Re: Planning Application 2025/1768/T (178 Camden Road)

RE: 2025/1768/T - planning application to remove a mature Ailanthus tree, protected by a TPO

## Re: 2025/1768/T – application to remove a mature Ailanthus tree, protected by a Tree Preservation Order, at 178 Camden Road to alleviate alleged subsidence damage to 180 Camden Road

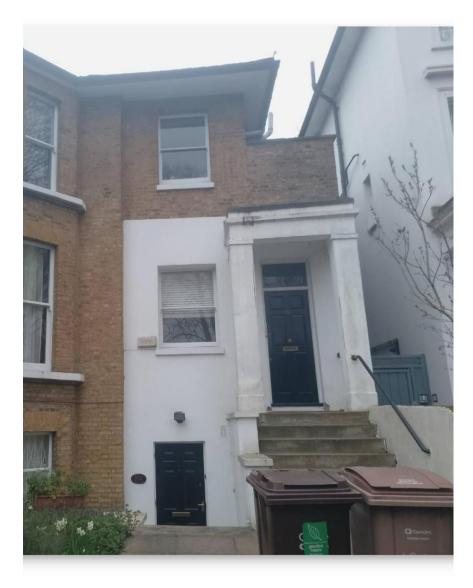
I also attach a photo of 180 taken from the Auger report. It seems that the issues where the subsidence are occurring are in the newer extension to the original property - is there any chance that there are any defects to the construction of the footings? It is strange to me that no subsidence issues have been observed at 178 and 180 (which are much closer to the tree).
